DOCKETED	
Docket Number:	23-OPT-01
Project Title:	Fountain Wind Project
TN #:	259437
Document Title:	County of Shasta's AB 205 Review and Comments on Fountain Wind Project
Description:	County of Shasta's AB 205 Review and Comments
Filer:	Kari Cameron
Organization:	County of Shasta
Submitter Role:	Public Agency
Submission Date:	10/2/2024 6:46:37 PM
Docketed Date:	10/3/2024

Re: Docket 23-OPT-01: County of Shasta AB 205 Review and Comments re
Fountain Wind Project - Wildfire, Tribal Cultural Resources, and Water
Supply Impacts and Overall Net Positive Economic Benefits Analysis

Subject: Fountain Wind Project – Discussion of fire behavior modeling results

Fountain Wind Project: Completeness Evaluation of the Net Economic Impact Study

Figure 1. Excerpts from the Pyroanalysis report showing flame lengths modeled under current conditions (left) and project conditions with mitigations (right). The blue circle shows an area where flame length increases instead of decreases, as might be expected with fuel reduction.

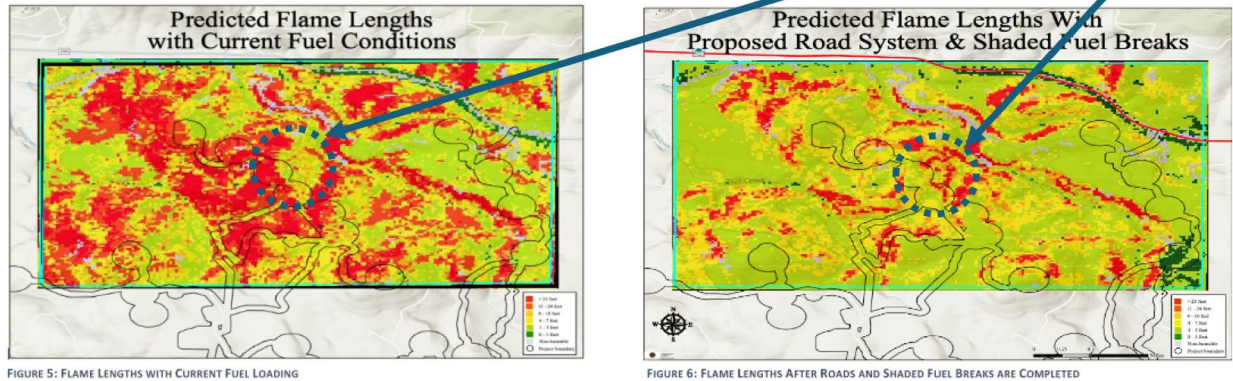
Our values diverge from the results of the Pyroanalysis study, which for conditions without the project, reports flame lengths exceeding 25 feet over nearly half the sample area and rates of spread of up to 50 chains/hr on representative slopes and ridges. Differences in our findings may be attributed to the nuanced wind field that is represented in our study, whereas the Pyroanalysis study uses a spatially static 12-mph wind speed. With the proposed project mitigations, the potential fire rate of spread in the project area is reported in the Pyroanalysis study to be reduced to 1 to 5 chains/hr. In addition, their results for flame lengths appear to be increased in some areas between current conditions and project conditions, as seen in the excerpts from their report in Figure 1. This is highlighted to show how the approach and subsequent results are unclear.

Figure 2. The Fountain Wind area is in the green rectangle, the Hatchet Ridge site on the ridge to the Northeast and the yellow is an area where we understand that retardant drops would be restricted due to watershed concerns.

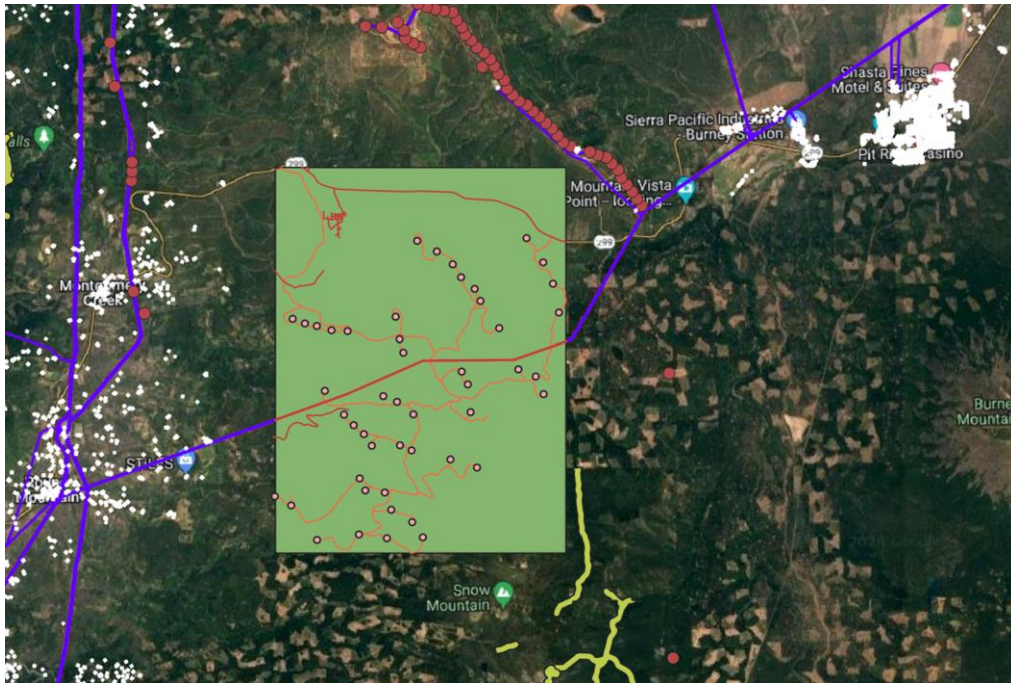
We are in the process of modeling fire spread for severe fire weather conditions and ignitions which occur in or near the Fountain Wind footprint using much of the approach quantified above. Fire perimeters are presented at discrete intervals vs. time from ignition out to approximately 6 hours. The simulated data can be used to evaluate the severity of a fire at the earliest time after fire detection that very large air tankers (VLAT's) would likely be above the fire line dropping retardant. This time would be based on an assumption that no flight restrictions are present in the area. Later times could be visualized to evaluate the fire perimeter after it has emerged from the restricted flight zone. Presumably, the later would be a larger and more challenging fire to control without having been subject to VLAT suppression activities at shorter times after ignition. The model assumes a circle around the project site that represents the restricted flight zone and that ignitions would occur near the upwind side of this area. The figure below shows the Fountain Wind area in the green rectangle, the Hatchet Ridge site on the ridge to the Northeast and the yellow is an area where we understand that retardant drops would be restricted due to watershed concerns.
